Access Compliance Report

Public Rights-of-Way

(Curb Ramps)

Intersection ID: 10040204	Main Street: TYVOLA_RD	Cross Street: N/A	Location: SE
ADA ID: 48674F992627	Ramp Type: PerpDiag	Initial Pass/Fail: Fail	Overall Compliance: No
		Severity Score: 21.25

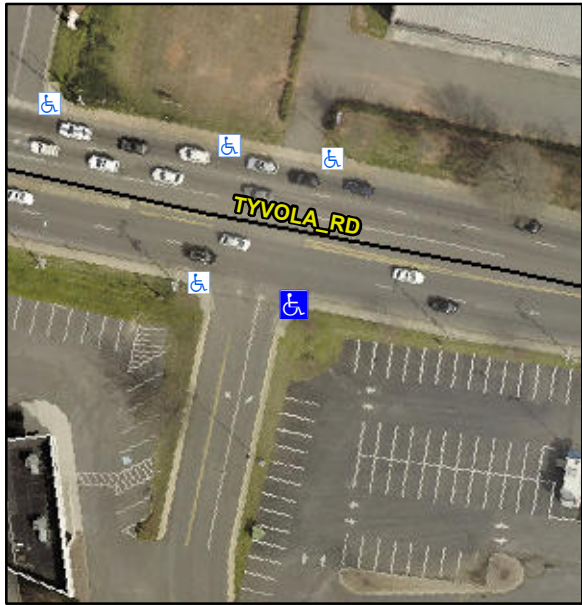
Codes/Mitigation Info/Possible Solution		Field Measurements/Component Compliance								
	Possible Solutions:				Compliance	Description	Data	Compliance	Description	Data
	Remove & Replace Curb Ramp With Two New Directional Ramps or Equivalent.	N/A	Ramp Length (in)	58.0	No	Ramp Slope (%)	9.3			
		No	Ramp Width (in)	43.0	Yes	Ramp XSlope (%)	1.9			
		N/A	Flare Type LT	N/A	N/A	Flare Type RT	N/A			
		N/A	Flare Slope LT (%)	N/A	N/A	Flare Slope RT (%)	N/A			
		N/A	Flare Traversable LT?	N/A	N/A	Flare Traversable RT?	N/A			
		N/A	Landing Length (in)	N/A	N/A	DWS Provided?	N/A			
		N/A	Landing Width (in)	N/A	N/A	DWS Contrast?	N/A			
		N/A	Landing Slope (%)	N/A	N/A	DWS Length (in)	N/A			
		N/A	Landing X Slope (%)	N/A	N/A	DWS Full Width?	N/A			
N/A	Landing Curb? (Y/N)	N/A	N/A	DWS Offset (in)	N/A					
Surveyor Notes:				N/A						
PROW/ADA:				N/A						
Not Found, R304.5.1, R304.2.2										
Total Cost:		\$	3200.00
